Wiltshire Council Planning Consultation Response

URBAN DESIGN

Application No: PL/2026/02930

Proposal: Residential development for up to 40 dwellings, associated works, infrastructure, ancillary facilities, open space and landscaping. Construction of a new vehicular access off Windsor Drive

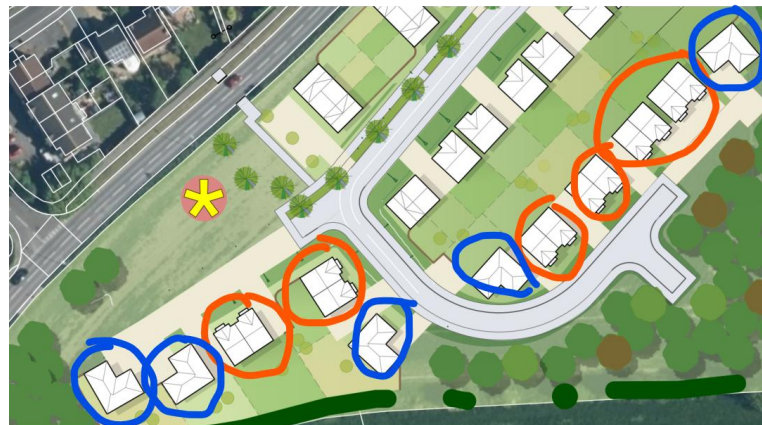
- 3) The play area is situated in an undesirable location being located next to Windsor drive and lacking sufficient screening. This risks creating a play space which is not well used as it is unlikely to encourage activity, play or social interaction. Due to the location this could end up aligning closely with 'red' examples in BfHL of poorly performing incidental spaces, rather than the preferred green approach of well-overlooked open spaces that contribute to legibility, neighbourhood identity and encourage activity.

Please see a 'green' example from BfHL below which shows a street which is deliberately wider incorporating green space and play between homes. Worth noting this also adds variation to the streets, creating a place of memorable character which aids legibility for people.

It is recommended that the play area is repositioned to a more appealing location. One possible solution could be to adopt a strategy like the above precedent and organise homes around a green area which incorporates green and blue infrastructure as well as a play area. Introducing greater multi functional landscape areas into the development would help improve legibility by creating a break in the streetscape. This would also be an attractive and memorable landscape feature to orientate houses around, please refer to p57 of BfHL. Please see screenshot/markup below indicating a multifunctional green space at the heart of the scheme.
